## **BID ADDENDUM NO. 6**

### **Johnson Student Center**

### **Building Demolition, Increment 1 (Demolition) and Increment 2**

RANCHO SANTIAGO COMMUNITY COLLEGE DISTRICT  
SANTA ANA, CA

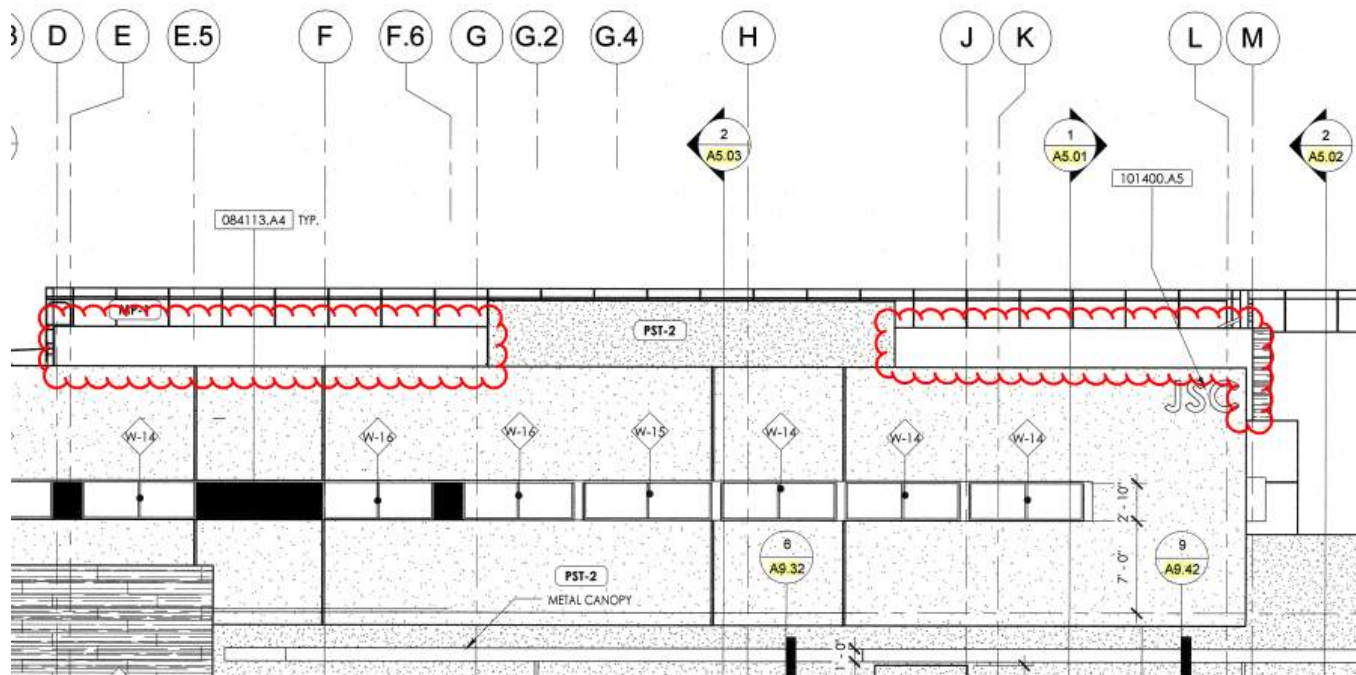
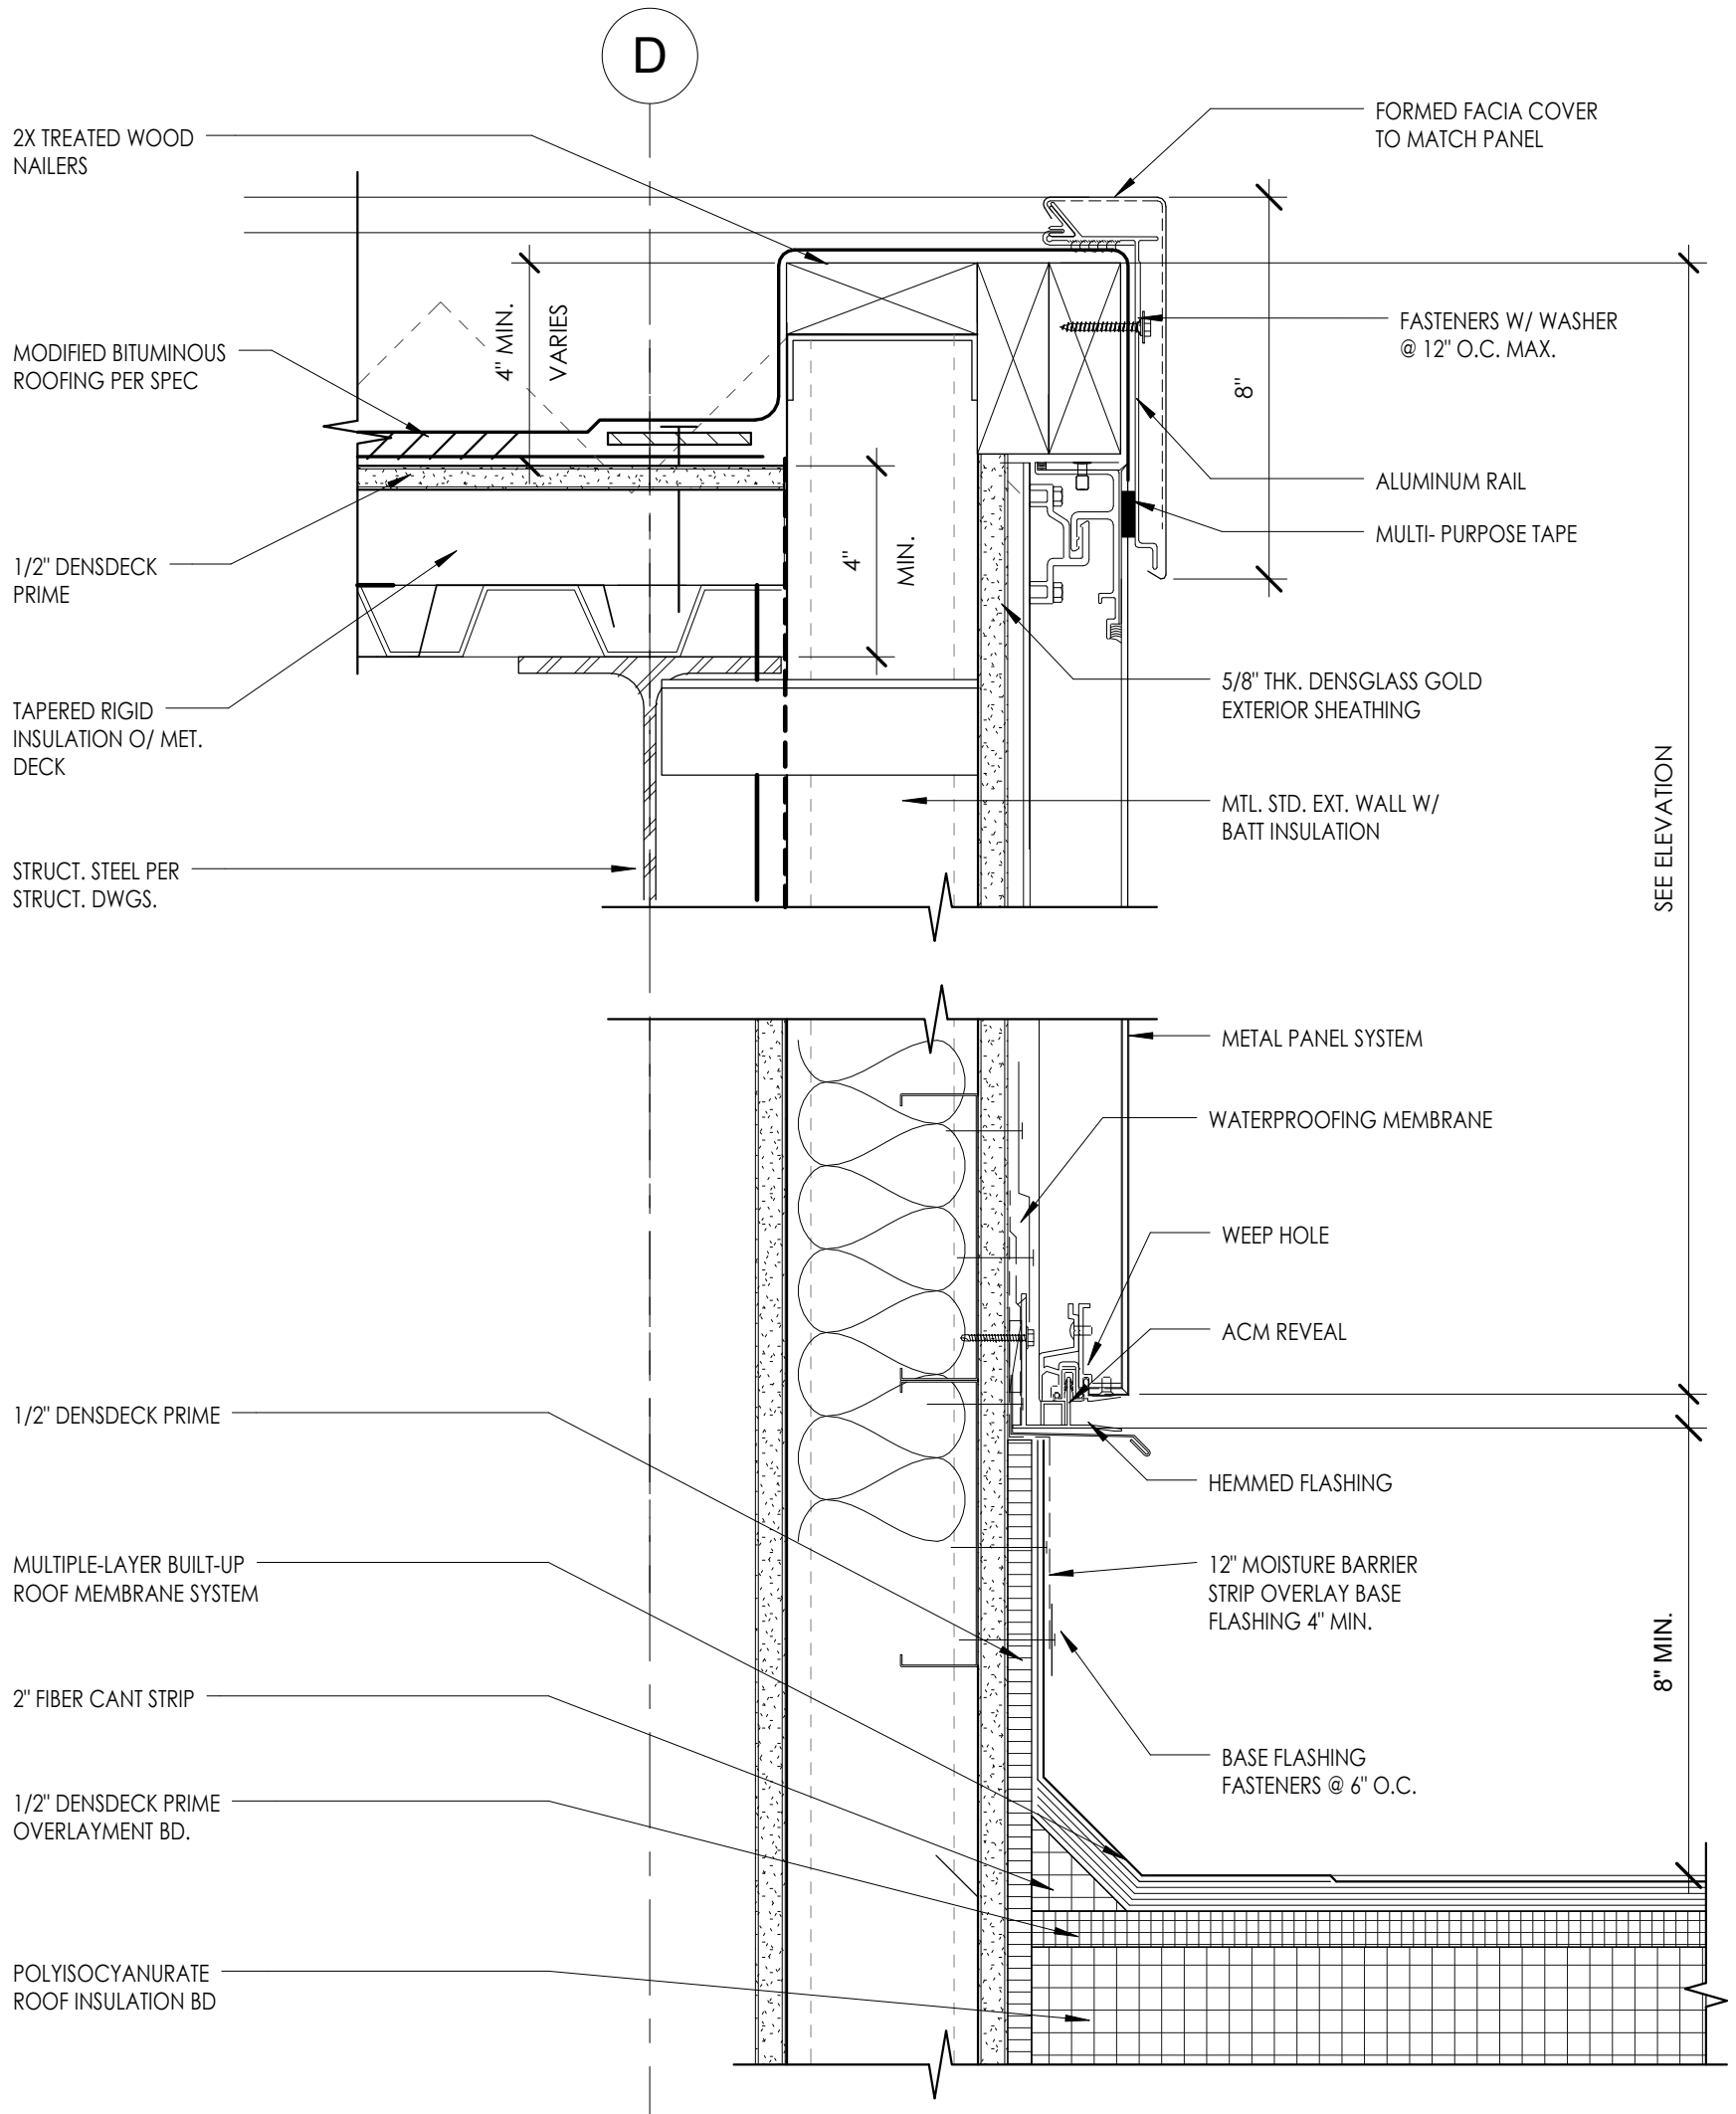
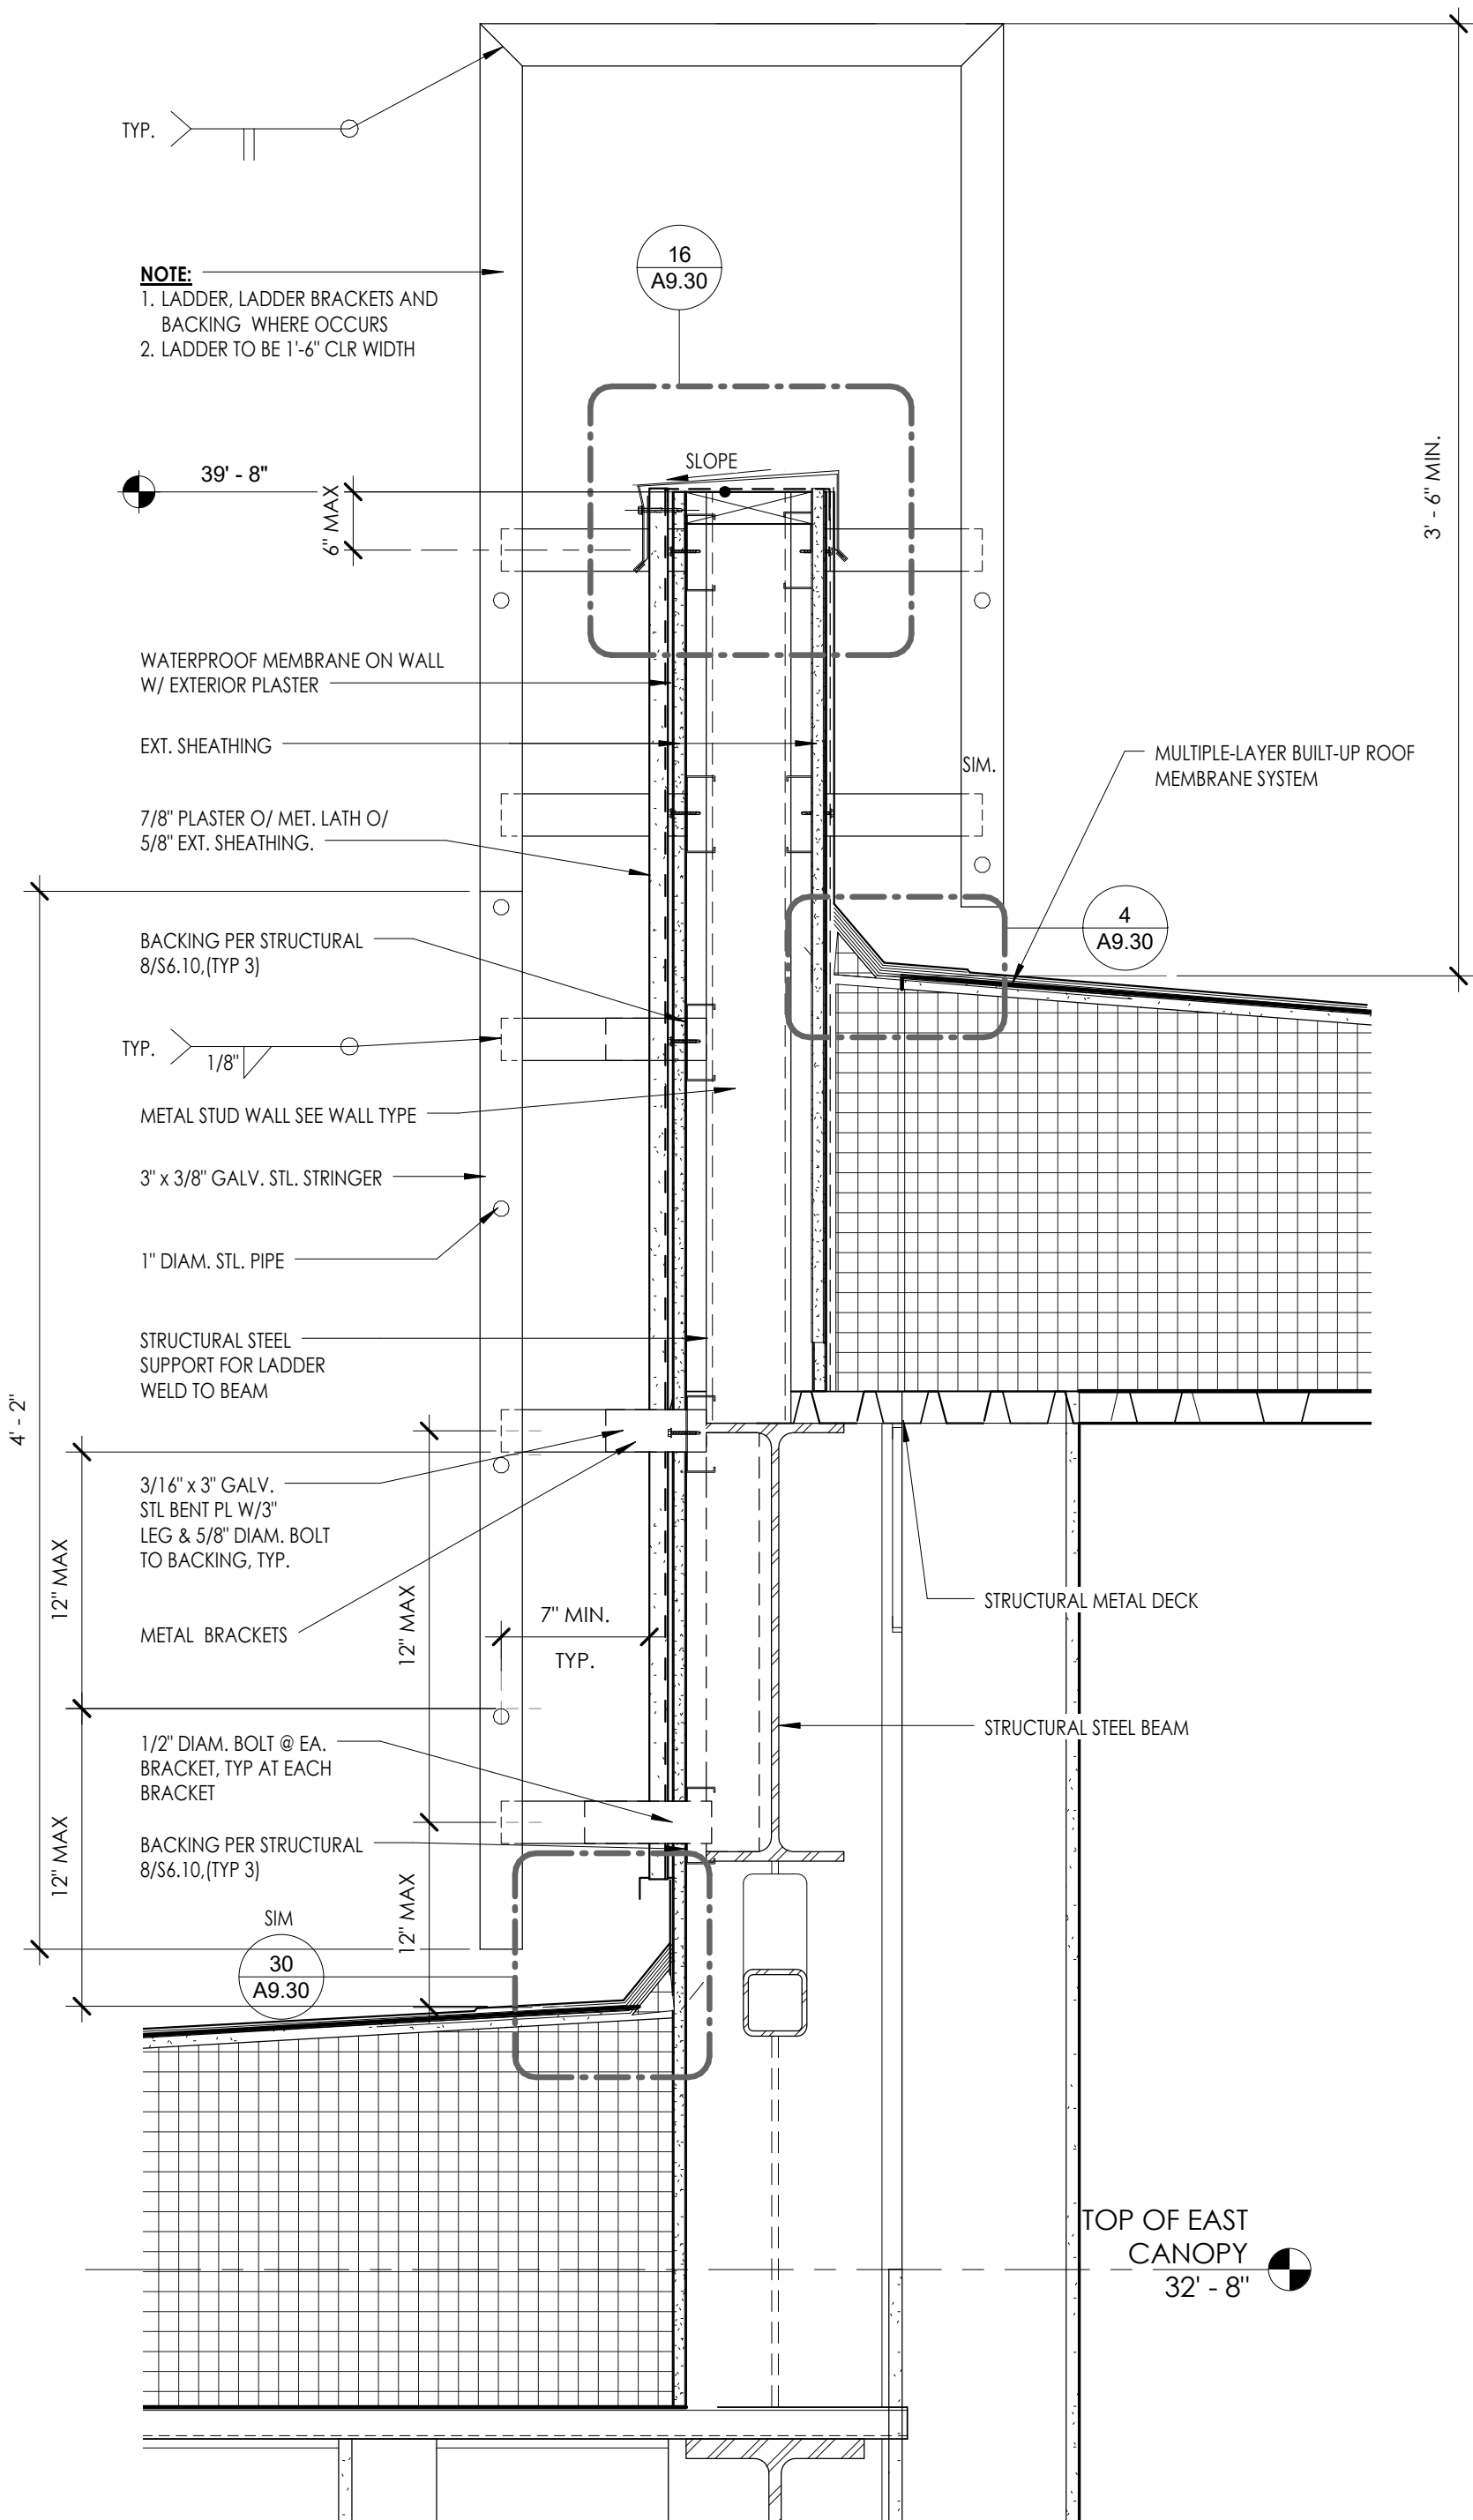
Increment # 2 – On sheet A2.30 along gridline D please clarify the parapet finish and the extent of each finish along this line. Wall cut 1/A5.03 near gridline 3.2 seems to indicate that the roofing wraps up the parapet on the west side, however detail 1/A9.31 at the access ladder seems to indicate that there is metal panel along this side of the parapet. Please clarify the west side and also confirm that the roofing on the east side of this parapet wall wraps up the roof to the parapet cap and is not something else.

Please also clarify the finish on the south side of the parapet along gridline 7. The only detail cut along this wall (27/A9.31) is for the screen wall at the AHU, which is not this wall. And the elevations for this area do not have a material call out (see attached). We are assuming the north side of this parapet wall is the roofing membrane wrapped up the wall.

- USE DETAIL 2/A9.32 FOR PARAPET BETWEEN GRIDLINE 3.2 & 3.9
- BETWEEN GRIDLINE 3.9 TO GRIDLINE 5 USE ATTACHED DETAIL RFC 66.1
- BETWEEN GRIDLINE 5 TO GRIDLINE 7, USE ATTACHED, RFC 66.2 (REVISED DETAIL 1/A9.31 - LADDER WHERE OCCUR)

- SEE ATTACHED PLAN FOR THE LOCATION OF TRESPA PANEL DIMENSIONED 19'-6"
- REFER TO DETAIL 1/A9.40 FOR TRESPA FLASHING AT PARAPET
- REFER TO ATTACHED RFC 66.3 FOR TRESPA BASE AT ROOF (PROVIDED DETAIL 1/RFC 66.3)
- @ PLASTER PARAPET USE ATTACHED, RFC 66.2 (REVISED DETAIL 1/A9.31)
